Service Bulletin

W-104

Models Z-180 (53AC235M190) and Z-200 (53AC275K190)
 Serial Numbers 144570 thru 144734, 163254 thru 163299, 203354 thru 204348
 Date July 2, 1997
 Subject SERVICE KIT 753-0706

Service Kit 753-0706

Figure 2

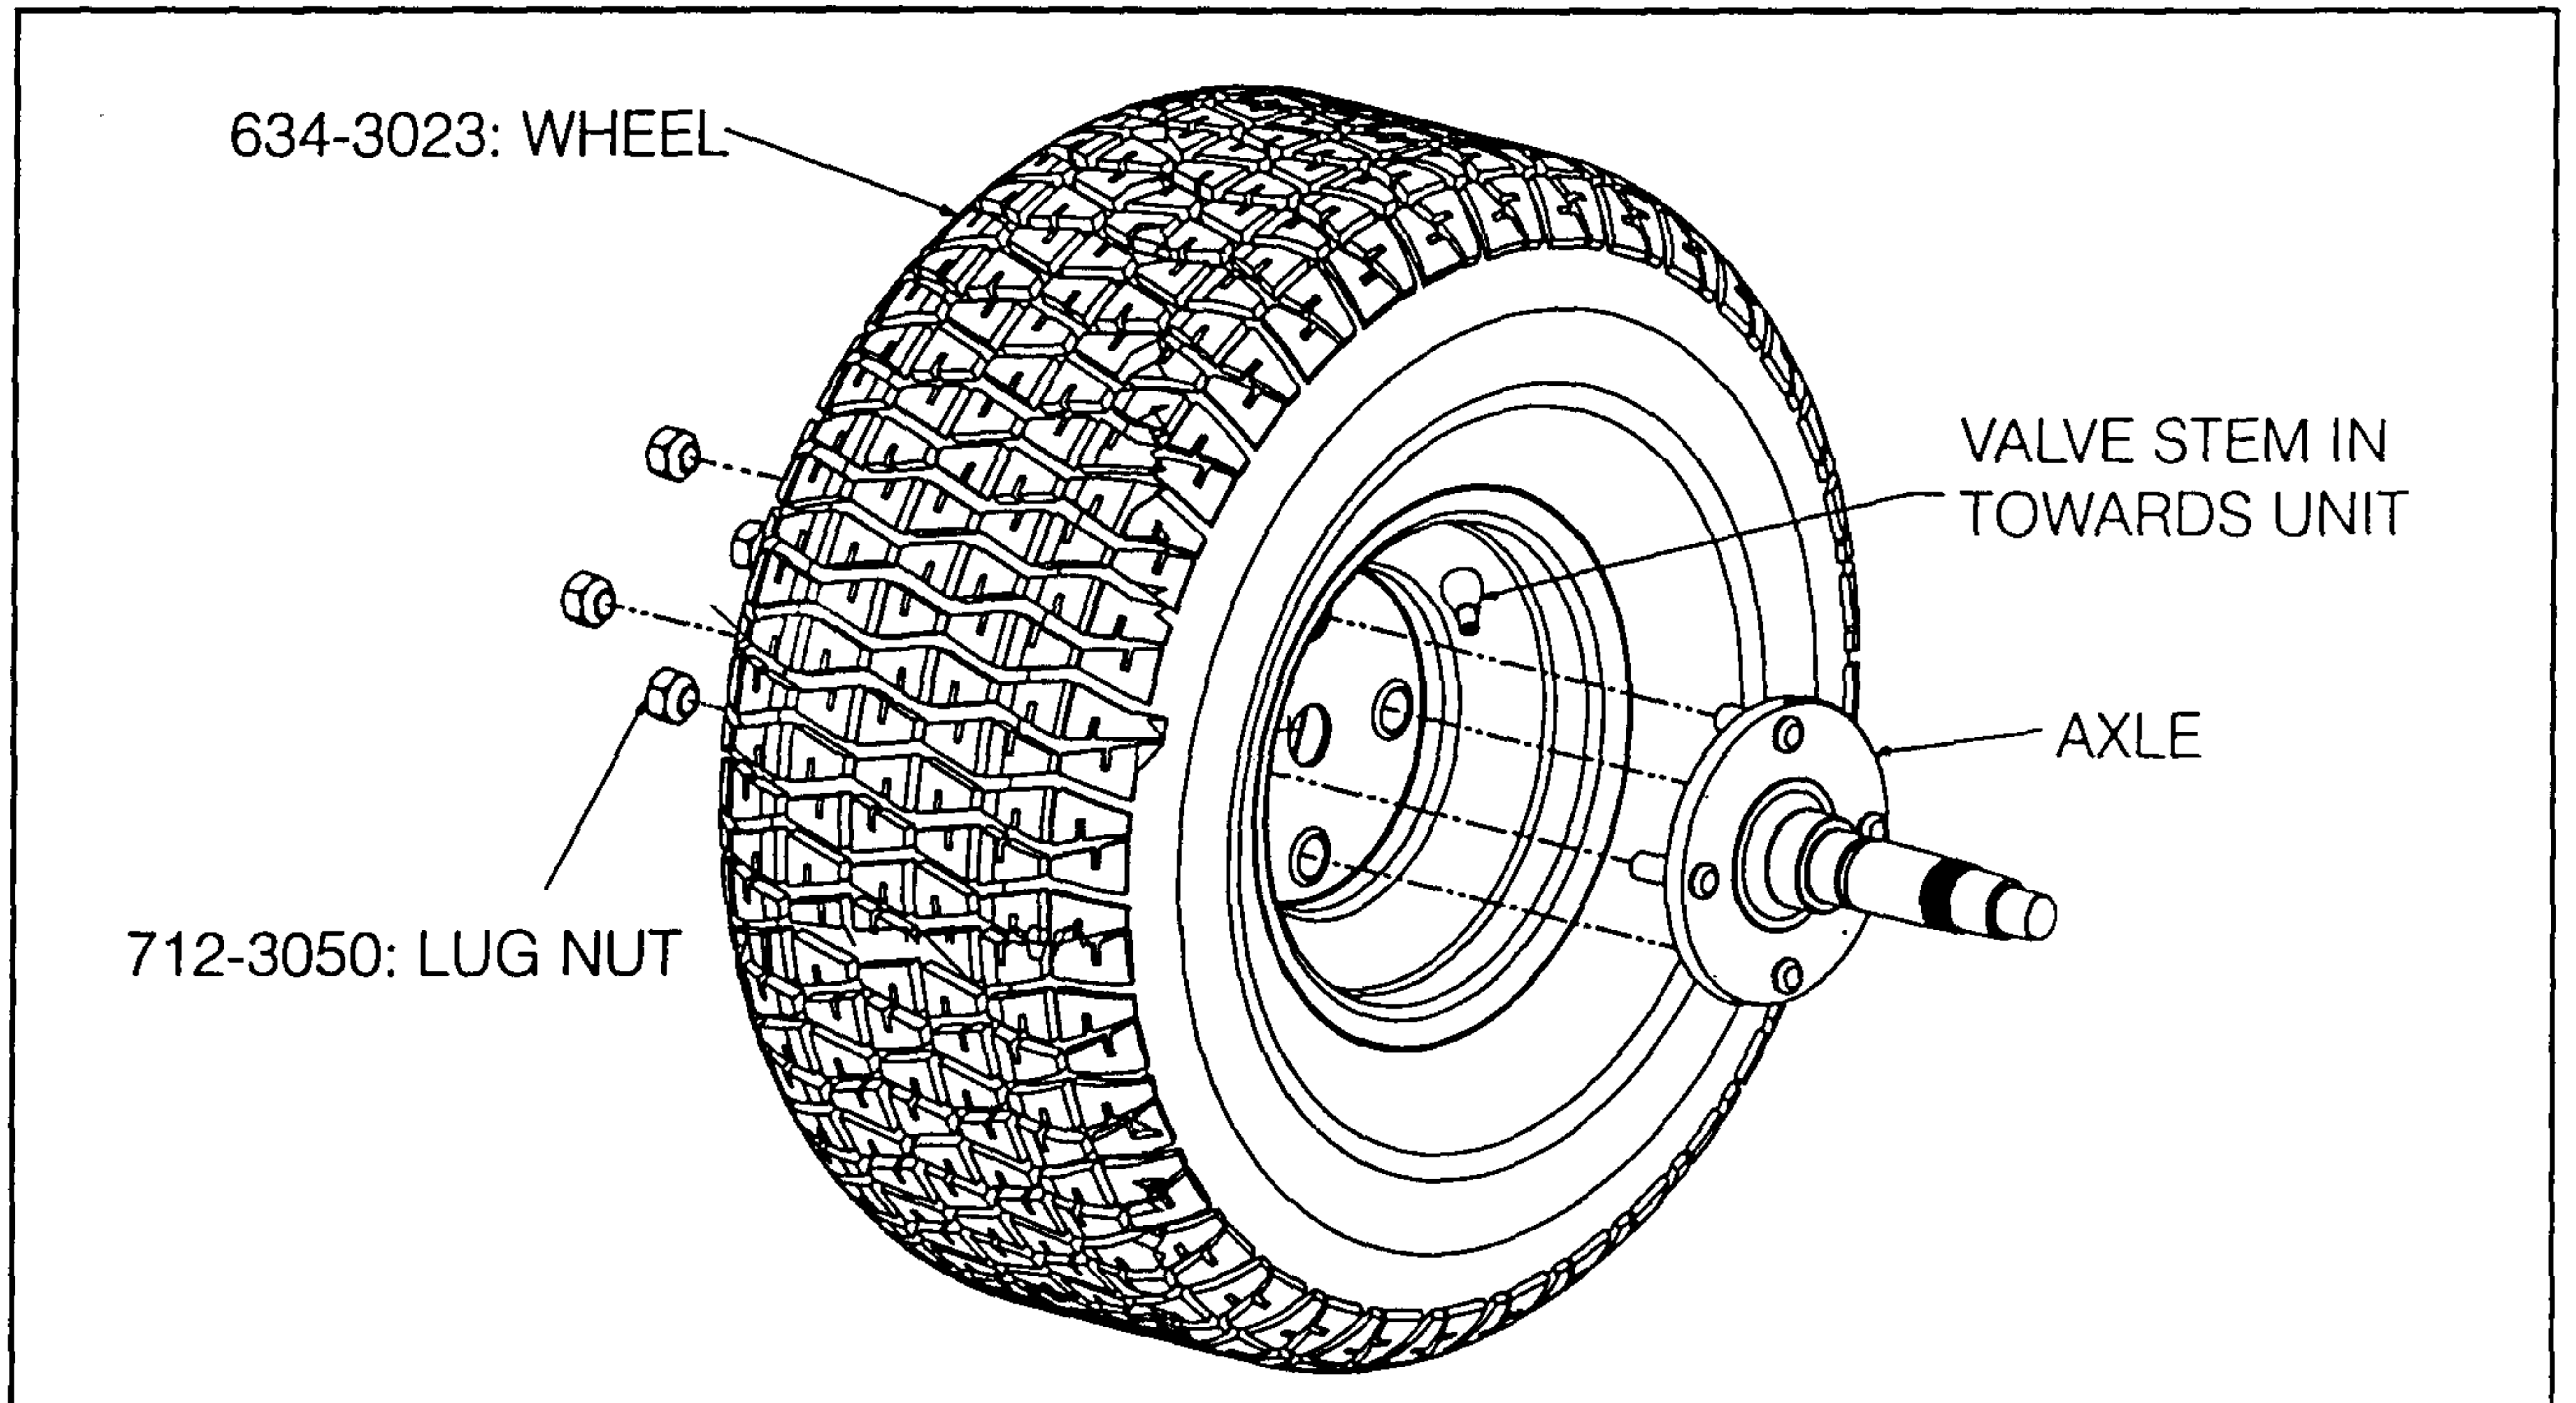
- A When the lift handle is located in first or second position, the deck drive belt may come off the deck pulley
- B Rear tire may come in contact with transmission assembly/ frame bolt
- C Engine cranks but will not start or starts hard

1. Jack Z-series so that both wheels can rotate freely.
2. Remove wheel on both right and left side.
3. Flip both wheels so valve stem is facing in; towards the unit. (See Fig. 2)
4. Position the wheel on the axle using center pilot as a locator.
5. Start all lug nuts on studs but do not tighten.
6. Finger tighten top nut, then rotate the wheel so that the number 2 nut (see Fig. 3) is at the top and finger tighten. Finger tighten remaining nuts in numerical (criss-cross) order.
7. Torque top nut to 50-60 ft.-lb. (600-700 in.-lb.). Rotate wheel so that the number 2 nut (see Fig. 3) is at the top. Torque nut to 50-60 ft.-lb. (600-700 in.-lb.). Torque remaining nuts in numerical (criss-cross) order.
8. Loosen lugnuts and repeat torque requirements as described above.

Figure 4

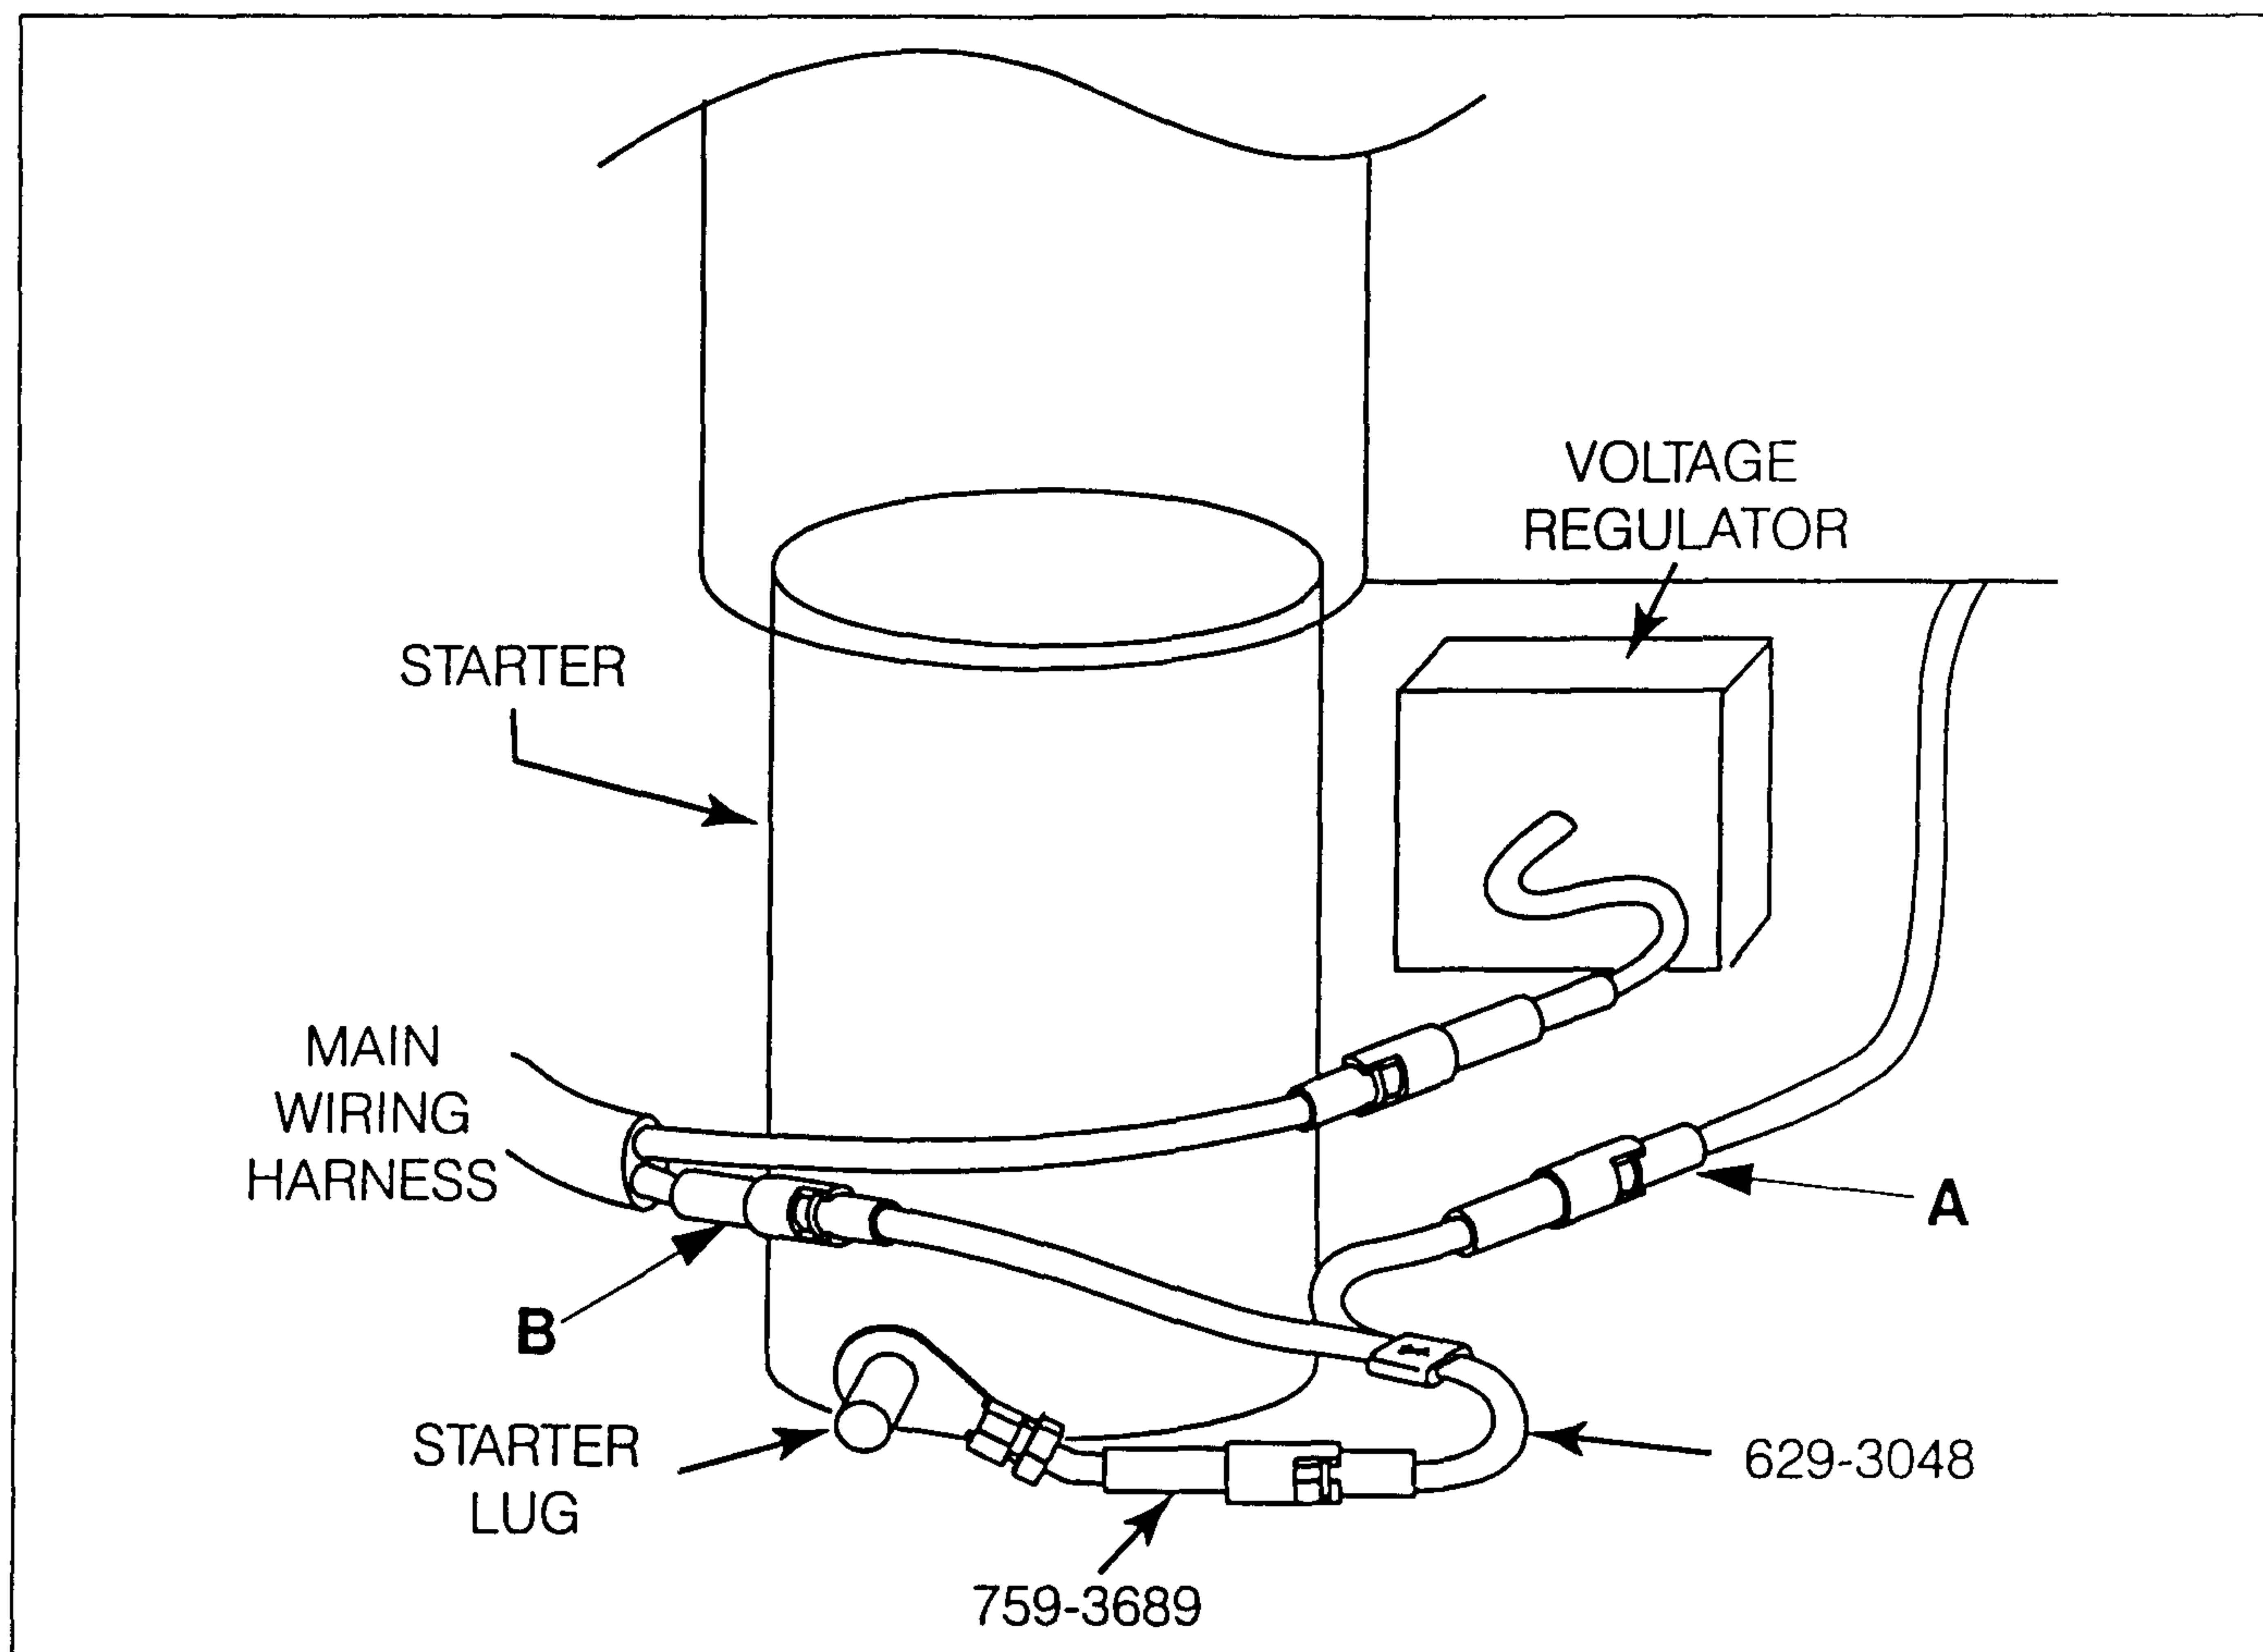
- B Refer to the instructions on back of this bulletin.
- C To correct this problem, an afterfire wire adapter and diode assembly must be added to the wiring harness. The afterfire device is a solenoid and plunger mounted on the carburetor which prevents the engine from "running on" after the key switch is turned off by stopping the flow of fuel in the carburetor. When the key switch is moved to the start position, battery current thru the diode assembly holds the solenoid plunger open and allows fuel to flow in the carburetor. When the key switch is released to the run position, current thru the wire adapter continues to hold the solenoid plunger open while the engine is running. The necessary parts and instructions for this repair will be included in kit 753-0706.

- 1 Remove (red) wire from starter lug by removing nut
- 2 Slip ring terminal of 759-3689 diode assembly over starter lug See Figure 4
- 3 Replace (red) wire earlier removed, and tighten nut
- 4 Disconnect wire **A** from wire **B** See Figure 4
- 5 Plug 629-3048 wiring harness adapter into loose connections See Figure 4
